Technical Service Bulletin

Topic	43 Air spring symbol lights up - DTC C118D01 Compressor for level control electrical error
Market area	United States 444 Volkswagen of America, Inc. (6444)
Brand	Audi
Transaction No.	2073034/8
Level	EH
Status	Released for publishing
Release date	Mar 12, 2025

43 Air spring symbol lights up - DTC C118D01 Compressor for level control electrical error

Figure 1. Compressor electronics control unit -J1135-.

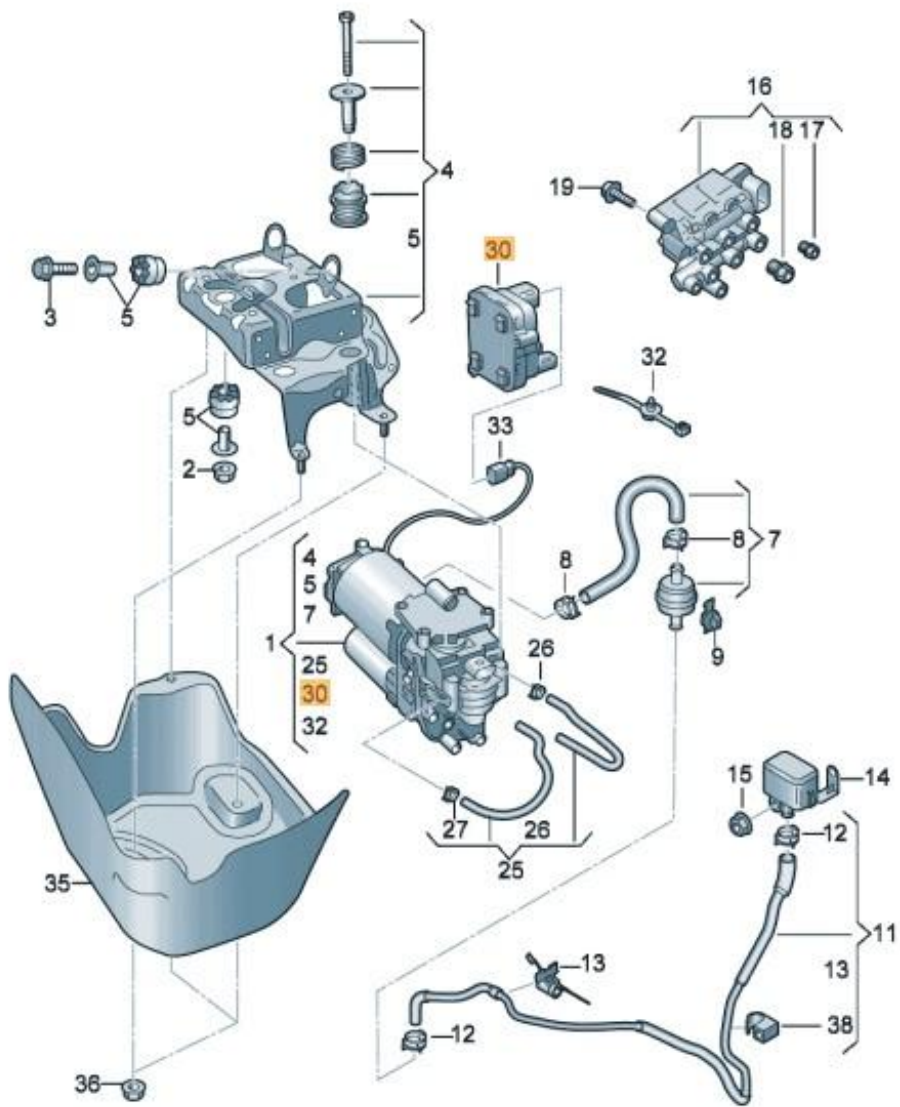
If no irregularities are found when checking the wiring/contacts at the air compressor and compressor electronics - J1135-, proceed as follows:

- Replace the control unit for compressor electronics -J1135- (**not the air compressor**).
- Please use part number **4M0.907.778**.
